Appeal 2015-005879
Application 13/442,998
Technology Center 2800

DECISION ON APPEAL

The invention relates to a device for supporting cantilever leads in a semiconductor package. Specification filed Apr. 10, 2012 ("Spec.") ¶ 2. Claim 29, the sole independent claim on appeal, is reproduced below:

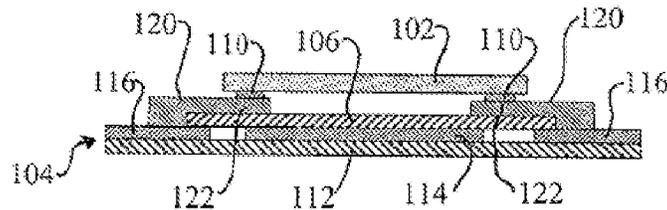
The Examiner finds the claim recitation “cantilever leads” reads on Choi’s electrically conductive paths 120. *See* Final Act. 4; Ans. 3. The Examiner further finds the claim recitation “non-conductive supports” reads on Choi’s non-conducting tape 106. Final Act. 4. Based on Choi’s Figure 5B illustration of the semiconductor package, the Examiner finds the thickness of a first end of each of Choi’s cantilever leads (electrically conductive paths 120), i.e., the end oriented away from the die mounting area, is greater than the thickness of a second end, i.e., the end oriented toward the die mounting area (i.e., the end adjacent a respective one of stud bumps 110). *Id.* (annotating Choi Fig. 5B). Based on Choi’s Figure 5B illustration of the semiconductor package, the Examiner finds the first and second ends of each of Choi’s cantilever leads (electrically conductive paths 120) form a recessed surface that is supported on one of Choi’s non-conductive supports (non-conducting tape 106). *Id.* (annotating Choi Fig. 5B).

The Examiner has not explained with sufficient clarity how the electrically conductive ink that forms Choi’s electrically conductive paths 120 is a structure formed from the material of Choi’s leadframe. *See* Ans. 3–4. Nor has the Examiner explained adequately how Choi’s non-conducting tape 106 has sufficient rigidity to support a cantilever lead formed from part of Choi’s leadframe when a die is mounted thereon. *See id.* The Examiner’s finding that Choi’s non-conducting tape 106 is a plastic (*see* Final Act. 5 (finding tape 106 meets the claim 35 recitation of a support comprising plastic)) is insufficient to establish that non-conducting tape 106 is a “non-conductive support[.]” within the meaning of the

claims, because the Examiner has not identified evidence that Choi's non-conducting tape 106 is constructed of a plastic having sufficient rigidity to support a cantilever lead in the manner recited in claim 29. We further note Choi's disclosure does not support the Examiner's finding that the ends of Choi's cantilever leads (electrically conductive paths 120) oriented away from the die mounting area have a greater thickness than the ends oriented toward the mounting area, as required by claim 29. *See* Final Act. 4. Choi describes only the ends oriented toward the mounting area as having "an enlarged portion or terminus 122." *See* Choi 5:9–11.

For the above reasons, Appellants have argued persuasively that the Examiner reversibly erred in finding claims 29, 31, 35, and 36 are anticipated by Choi.
